Architect's Supplemental Instructions

Architect's Project No:
04561.01

Architect's ASI No: 025

See attached Exhibit A, and the above sheet list for rooms and locations of the point-of-use ANT, acid vent routing, piping diagrams, risers and acid vent through the roof locations.

P0111.A

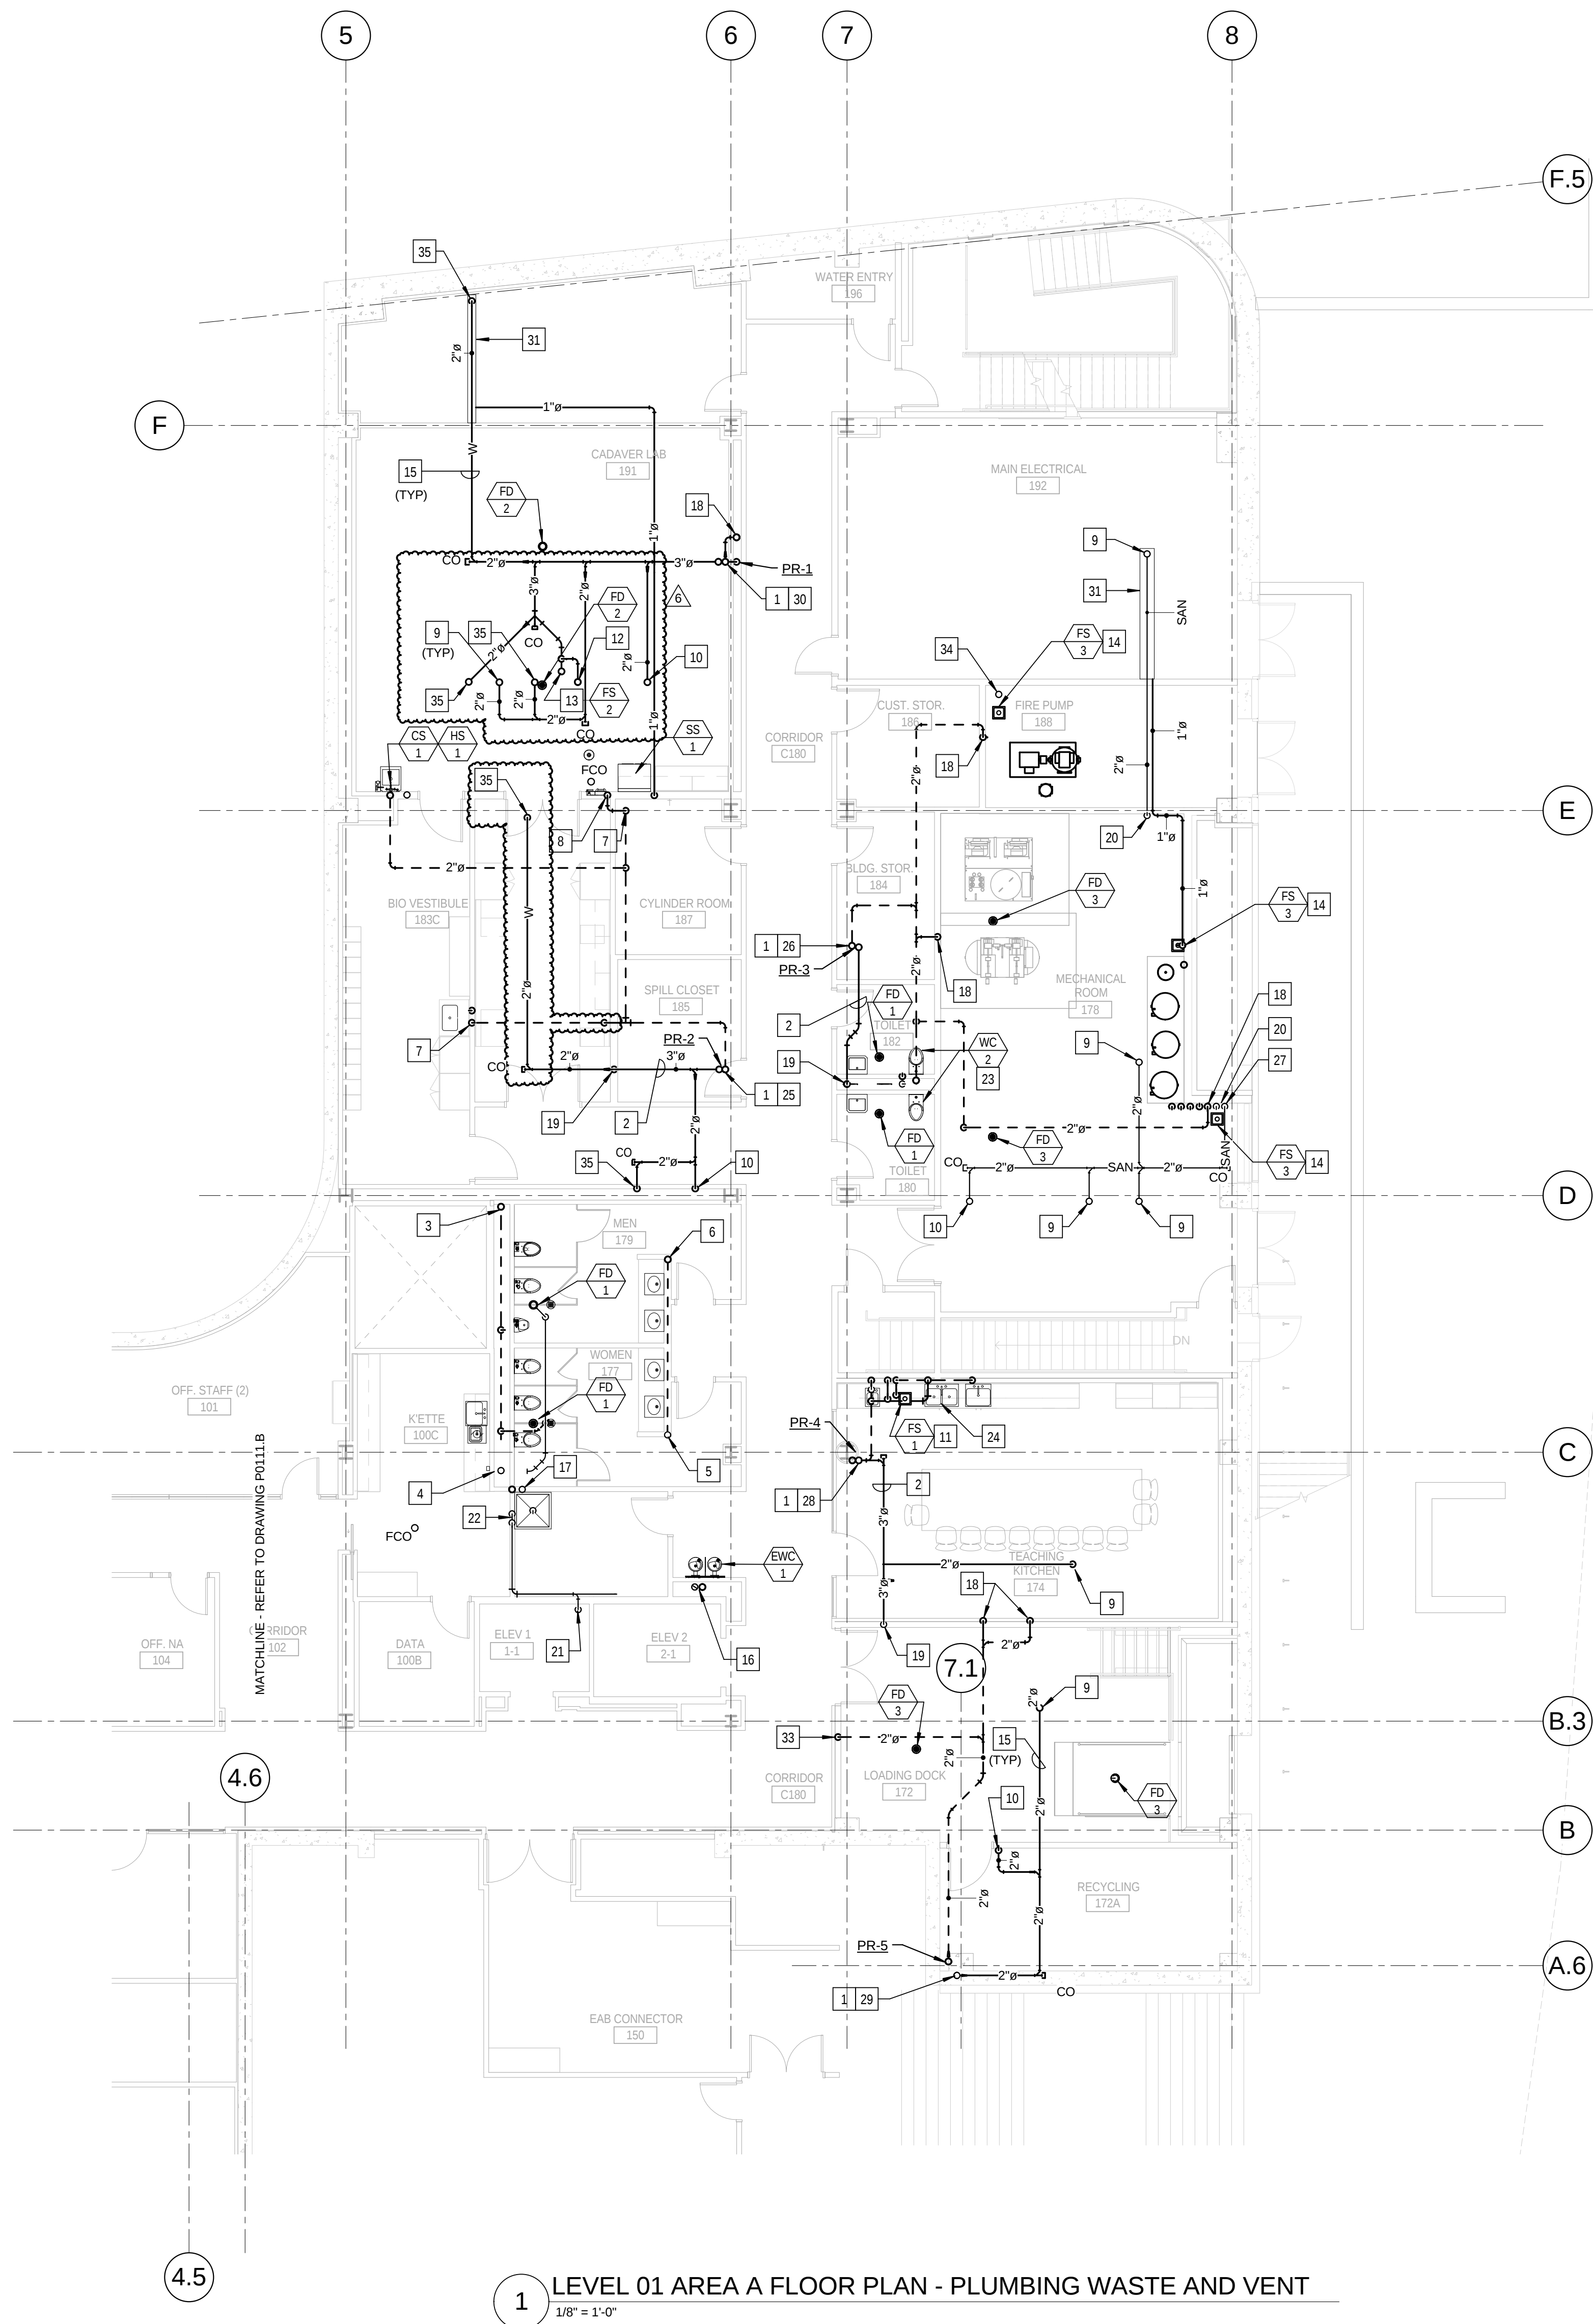
Note six floor sinks serving glass washers have been removed. Associated waste and vent piping to the floor sinks have been either delete or reduced in size to two-inch diameter. Glass washers are now being piped into the ANT.

- NOT USED.
- 2" VENT DOWN IN WALL TO SERVE FLOOR DRAIN IN LOADING DOCK.
- 4" C.I. STANDPIPE FOR SPRINKLER DRAIN. STUB 24" AFF.
- 2" SANITARY WASTE UP TO POINT-OF-USE NEUTRALIZATION TANK.

1 LEVEL 02 AREA A FLOOR PLAN - PLUMBING WASTE AND VENT
1/8" = 1'-0"

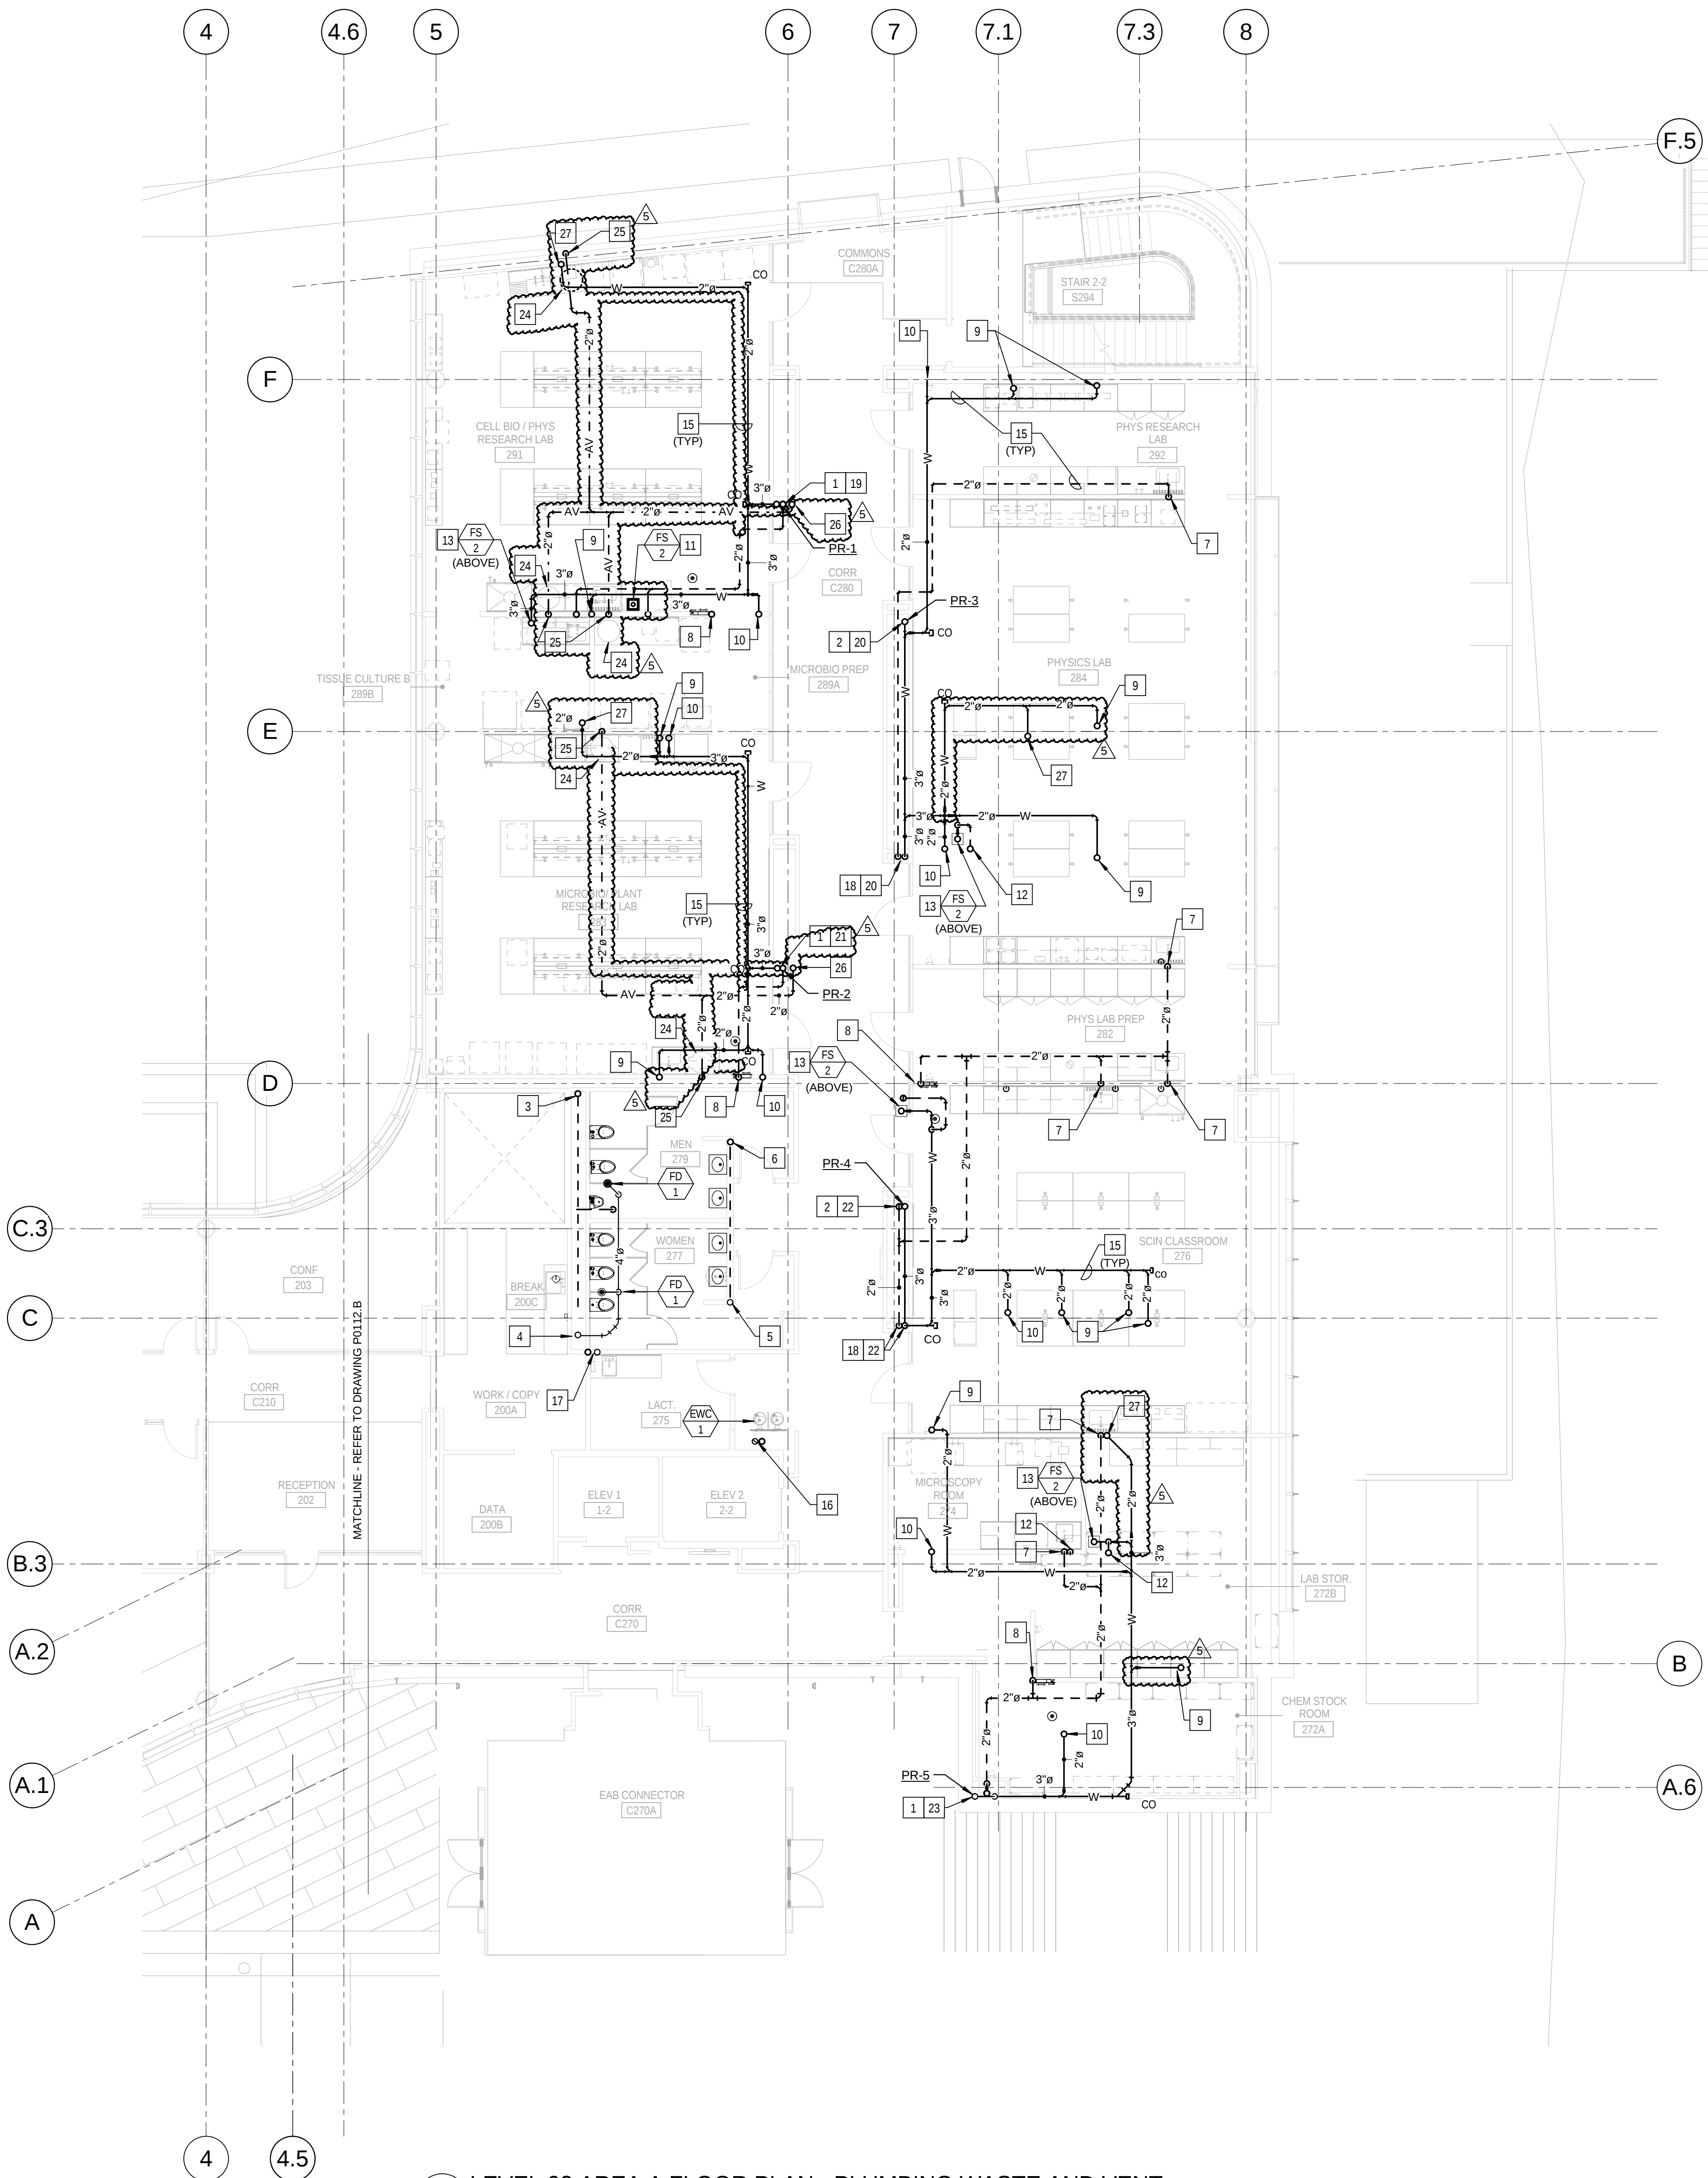
- 5-GALLON NEUTRALIZATION TANK WITH SLIP-ON COVER. LOCATED BELOW THE COUNTERTOP. REFER TO DRAWING P0404, DETAILS 1 AND 2 FOR PIPING DIAGRAM INSTALLATION.

P0112.A

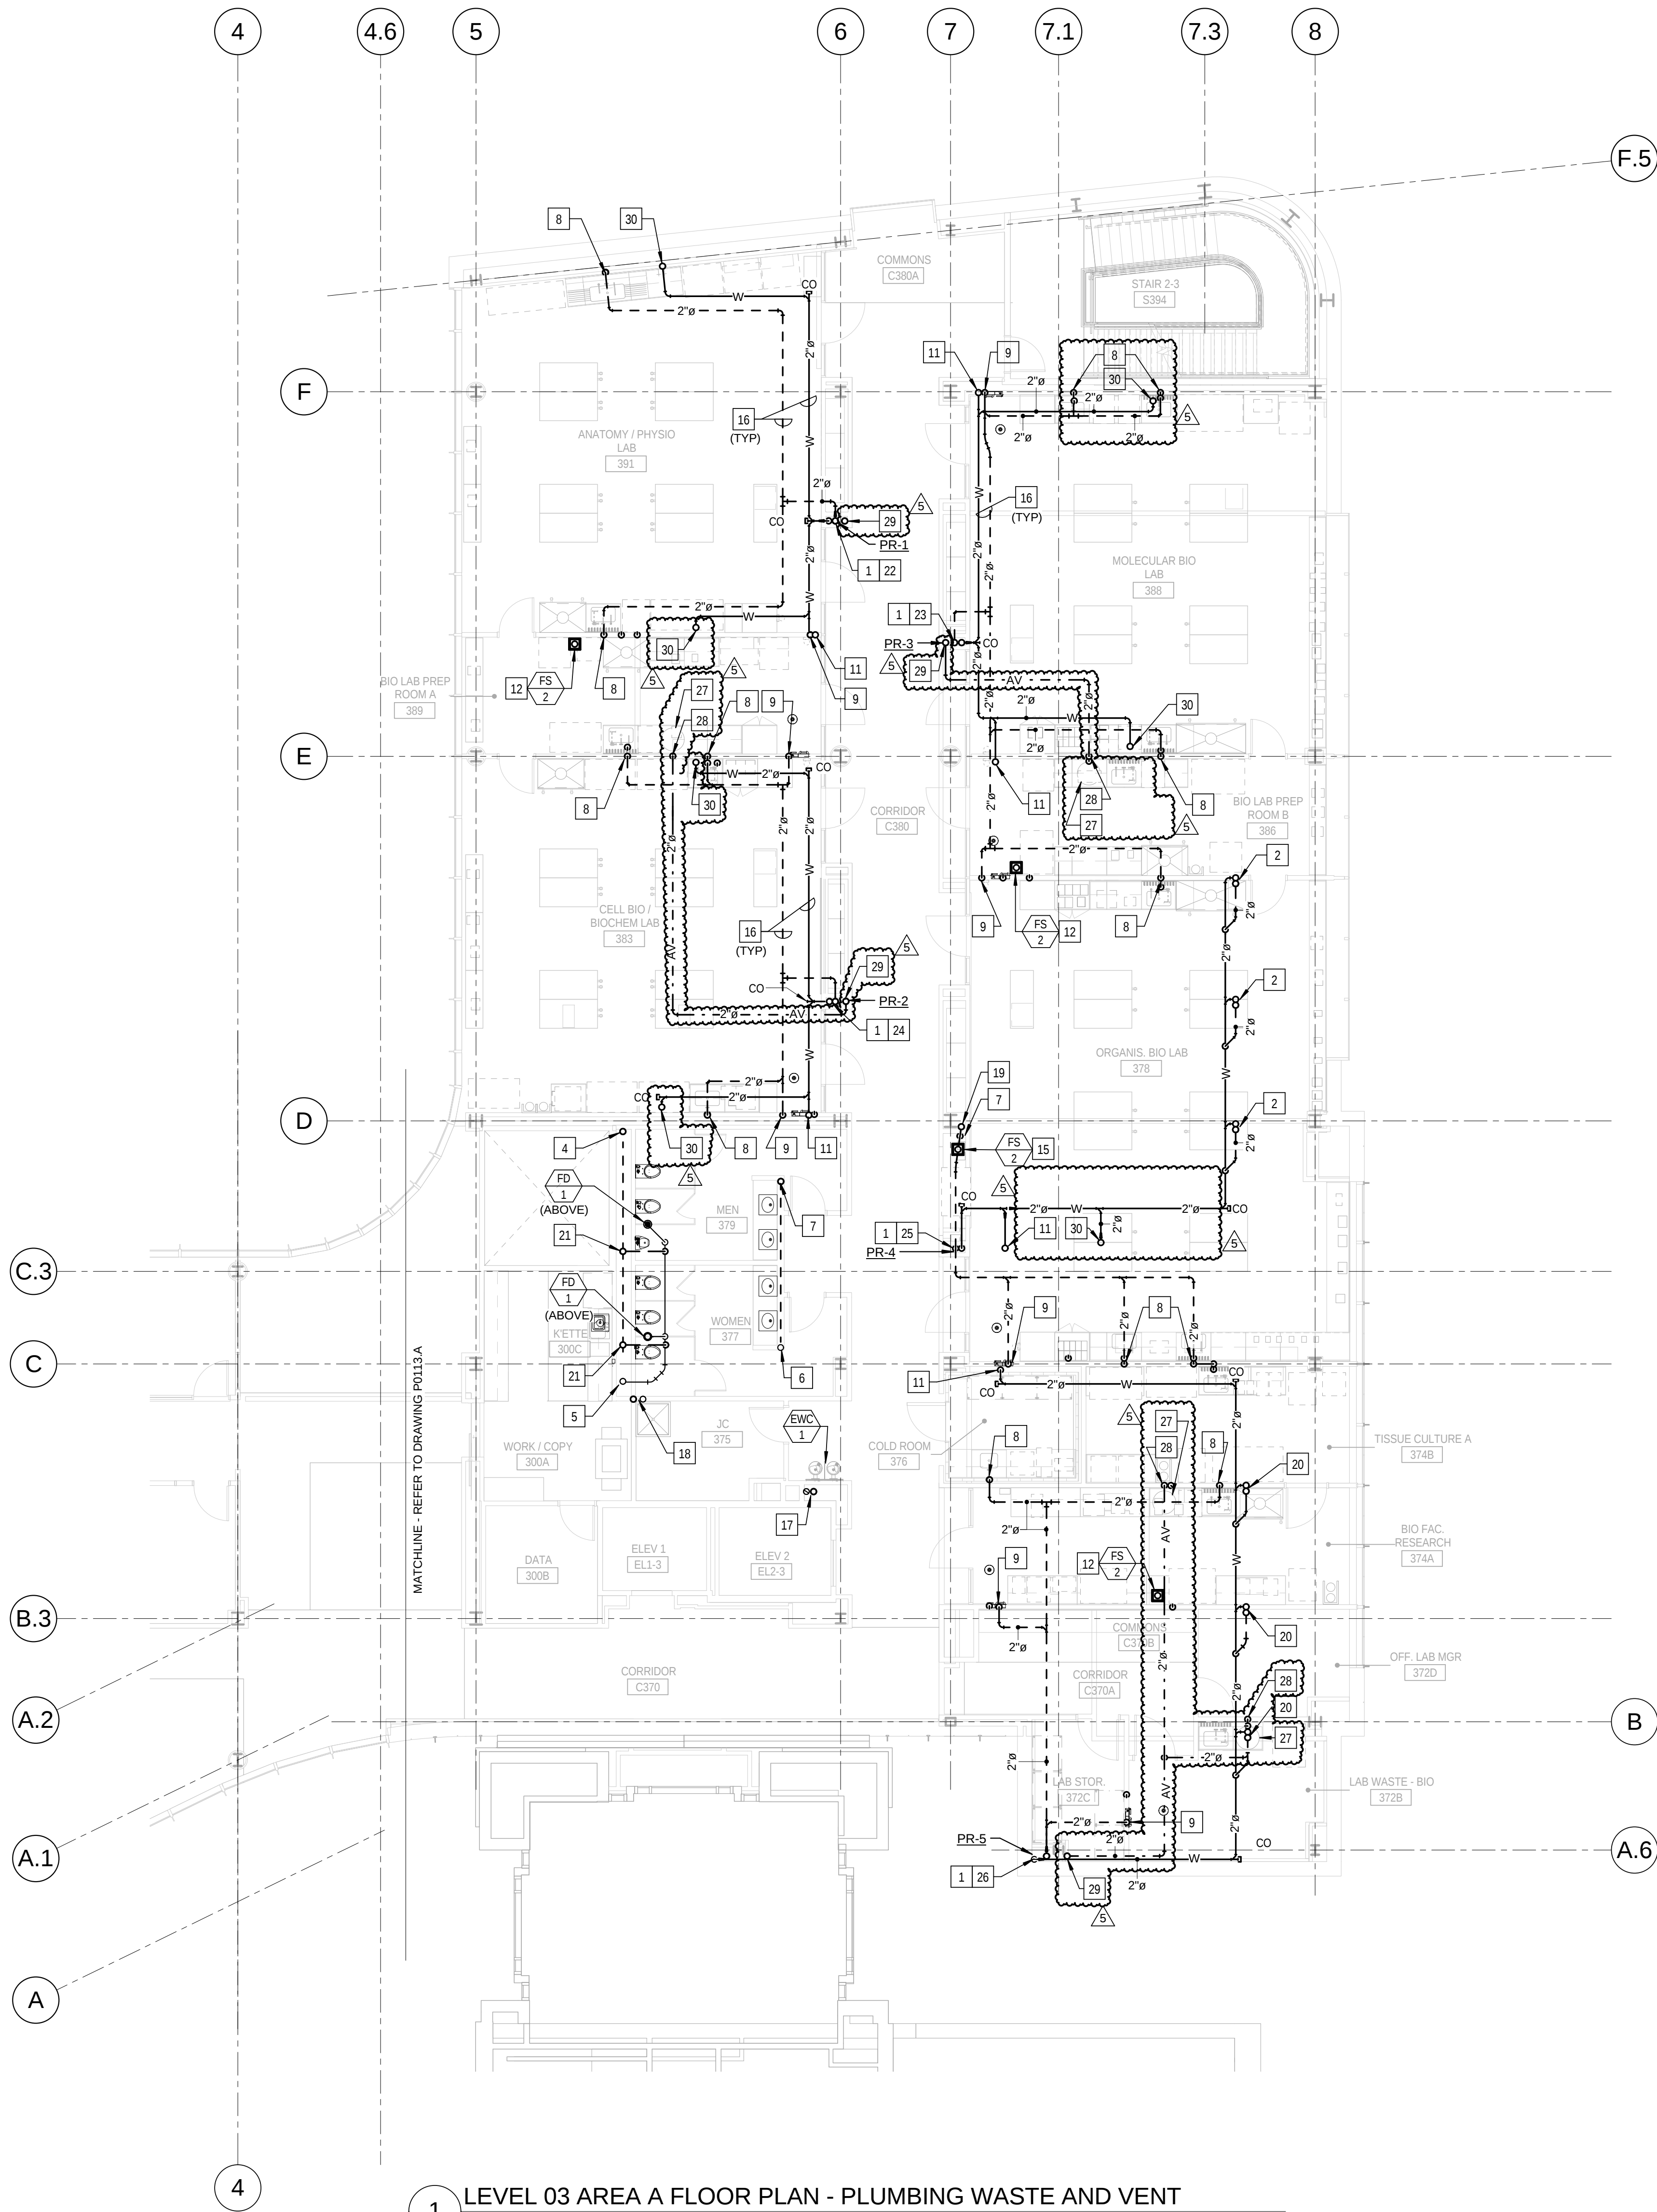
- 5-GALLON NEUTRALIZATION TANK WITH SLIP-ON COVER, LOCATED BELOW THE COUNTERTOP. REFER TO DRAWING P0404, DETAILS 1 AND 2 FOR PIPING DIAGRAM INSTALLATION.
